Access Compliance Report

Public Rights-of-Way

(Pedestrian Signals)

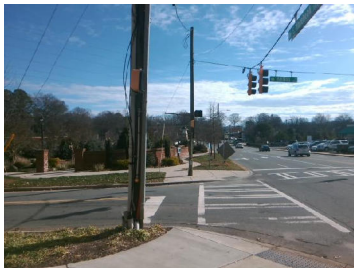
No	B 1 Clear Xing Direction?	NotClearlyMarked	N/A	B 2 Clear Xing Direction?	N/A
	B 1 Crossing Direction	To SW		B 2 Crossing Direction	N/A
Yes	B 1 DistanceTo XWalk (in)	0.0	N/A	B 2 DistanceTo XWalk (in)	N/A
Yes	B 1 DistanceTo Curb (in)	24.0	N/A	B 2 DistanceTo Curb (in)	N/A
Yes	B 1 Diameter (in)	2.0	N/A	B 2 Diameter (in)	N/A

Possible Solutions: Install Sign. Remove & Replace Crossing Striping. Provide PAR As Indicated. Provide Clear Space.
